NINE MILE POINT NUCLEAR STATION, UNIT NO. 1

AMENDMENT TO FACILITY OPERATING LICENSE

Amendment No. 47
License No. DPR-63

SAFETY EVALUATION BY THE OFFICE OF NUCLEAR REACTOR REGULATION
SUPPORTING AMENDMENT NO.47 TO FACILITY OPERATING LICENSE NO. DPR-63

Figure 3.1.7d Maximum Allowable Average Planar LHGR Applicable to P8DNB277 and Future Reload Fuel as described in Reference 8.

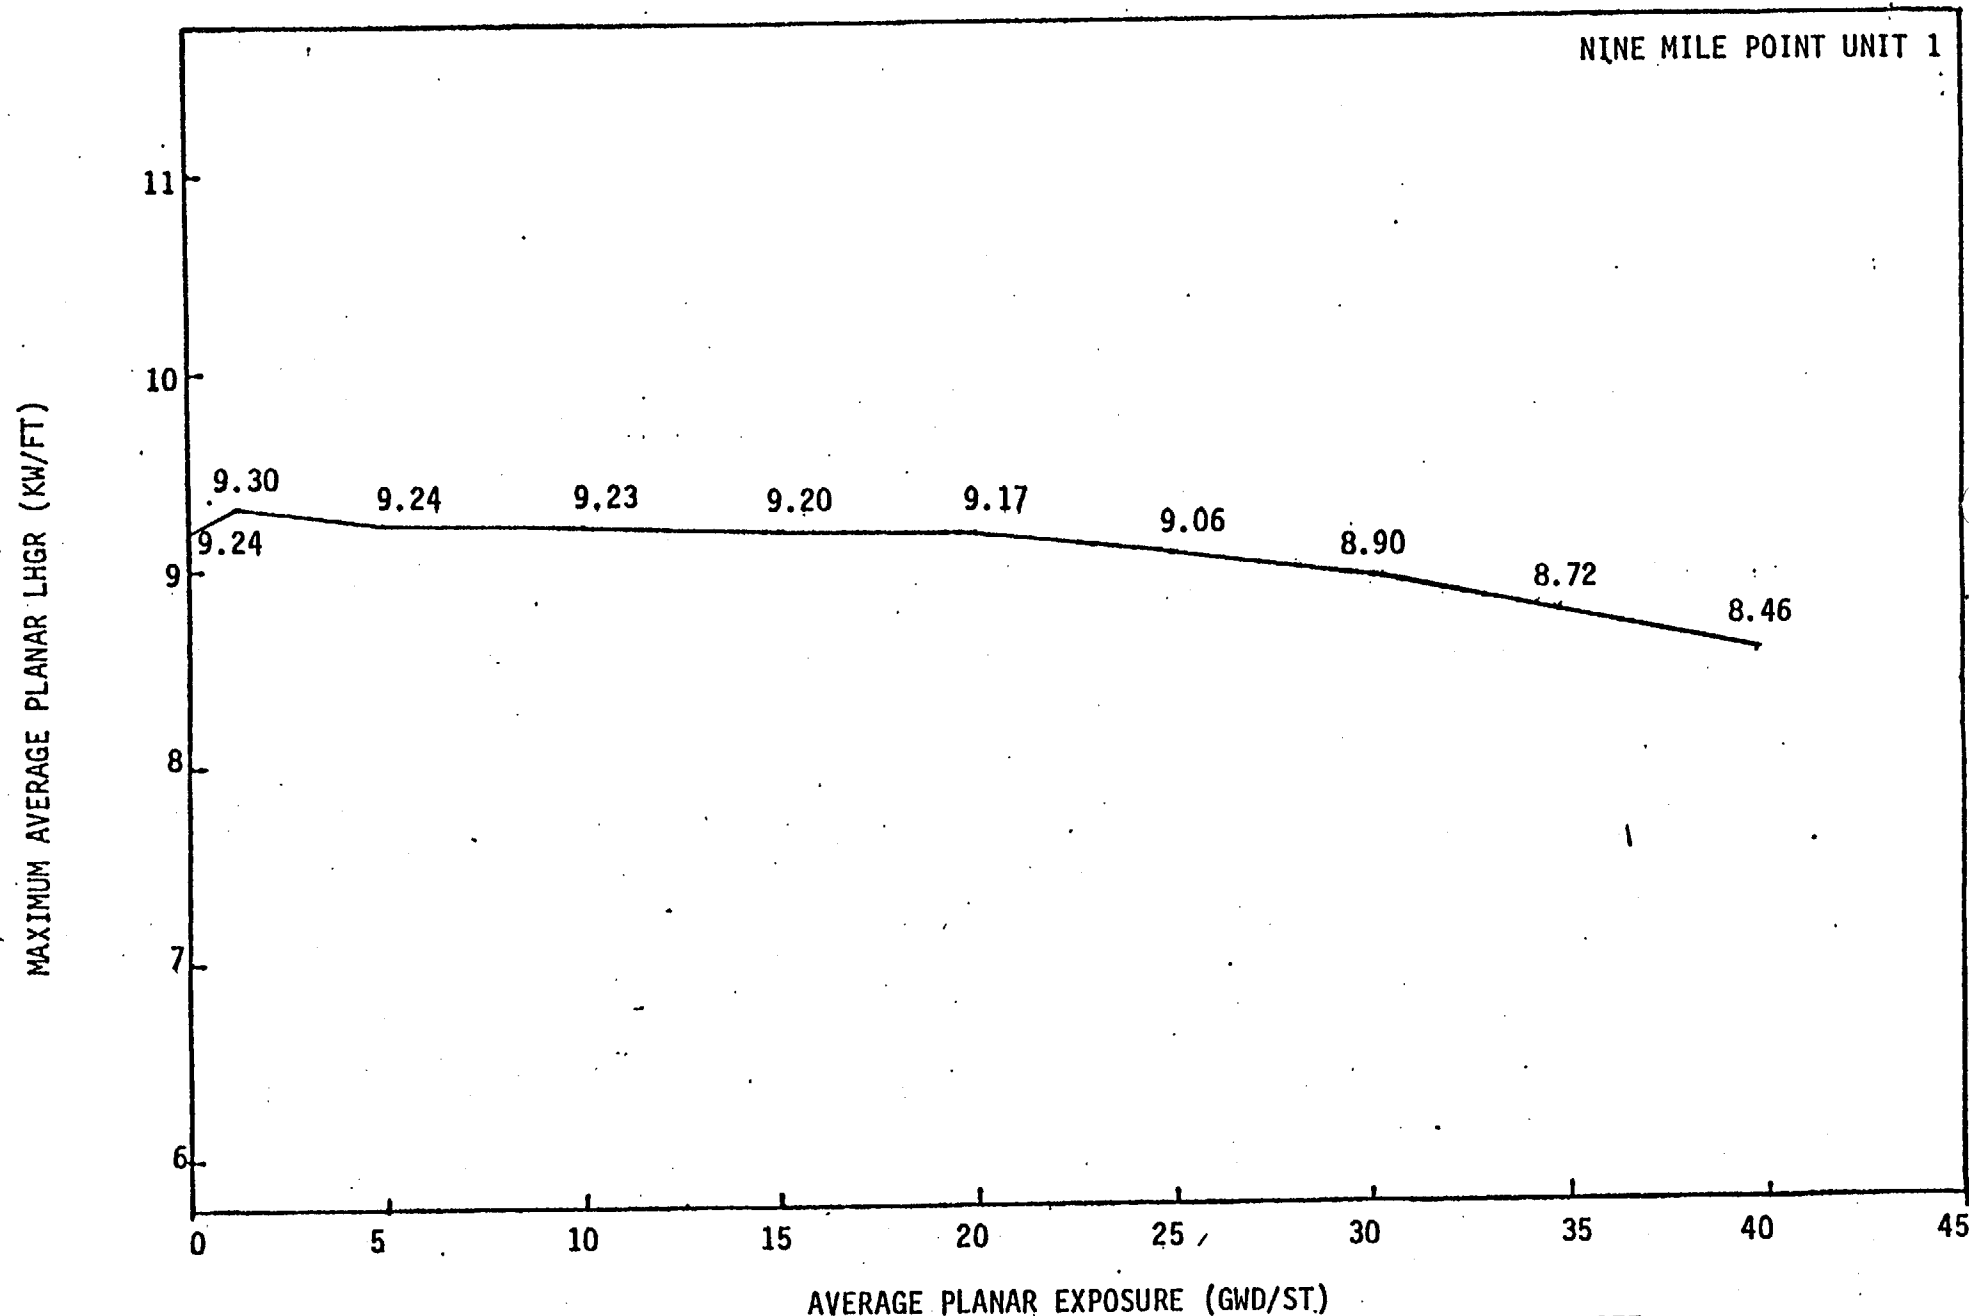
The Commission has issued the enclosed Amendment No. 47 to Facility Operating License No. DPR-63 for the Nine Mile Point Nuclear Station Unit No. 1. The amendment is in response to your request dated October 26, 1981 and it revises Maximum Average Planar Linear Heat Generation Rate (MAPLHGR) Technical Specifications.

The amendment revises the Technical Specifications to modify the Maximum Average Planar Linear Heat Generation Rate.

When operating with four recirculation loops in operation and the remaining loop unisolated, the reactor may operate at 100 percent of full licensed power level in accordance with Figure 3.1.7aa and an APLHGR not to exceed 98 percent of the limiting values shown in Figures 3.1.7a, 3.1.7b, 3.1.7c, 3.1.7d, and 3.1.7e.

When operating with four recirculation loops in operation and one loop isolated, the reactor may operate at 100 percent of full licensed power in accordance with Figure 3.1.7aa and an APLHGR not to exceed 98 percent of the limiting values shown in Figures 3.1.7a, 3.1.7b, 3.1.7c, 3.1.7d, and 3.1.7e, provided the following conditions are met for the isolated loop.

When operating with three recirculation loops in operation and the two remaining loops isolated or unisolated, the reactor may operate at 90 percent of full licensed power in accordance with Figure 3.1.7aa and an APLHGR not to exceed 96 percent of the limiting values shown in Figures 3.1.7a, 3.1.7b, 3.1.7c, 3.1.7d, and 3.1.7e.
